SERVICE BULLETIN

SUBJECT: Champion Aerospace SLICK Service Bulletin
SB1-15A

PURPOSE: Potential decreased service life of SLICK 4-cylinder magneto distributor gear assemblies.

SUBJECT: Potential decreased service life of Slick 4-cylinder magneto distributor gear assemblies. **Based on process and component improvements following the initial release of this service bulletin, the serial number range is being extended in this revision. Magnetos previously returned for compliance to SB1-15 must be returned or inspected for compliance to this revision SB1-15A.**

Figure 5. K3008 Distributor Gear With Monel Electrode

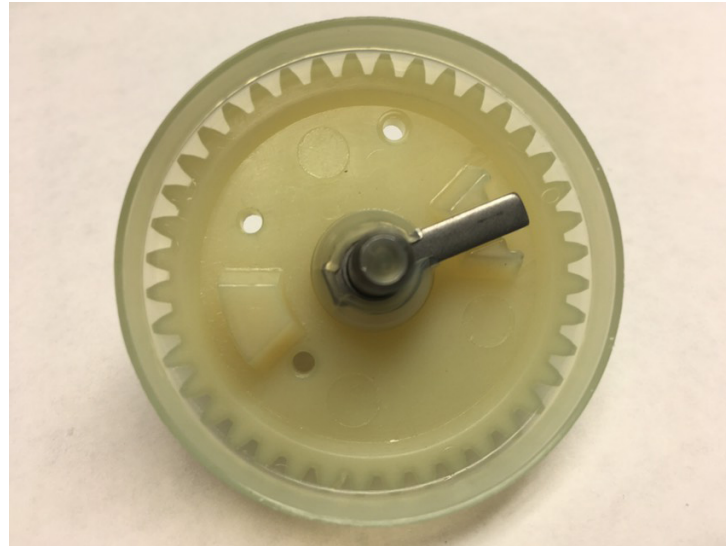
If it is not possible to confirm the version of the distributor gear that is installed in a given magneto from maintenance records, the magneto may be removed from the engine in order to have the housing and distributor block removed to allow visual inspection of the distributor gear. Distributor gears with Copper electrodes must be replaced with distributor gears with Monel electrodes.

REMOVE K3008 distributor gear assembly in subject magnetos and REPLACE with replacement K3008 distributor gear assembly **as soon as possible**, not to exceed the next 50 hours.
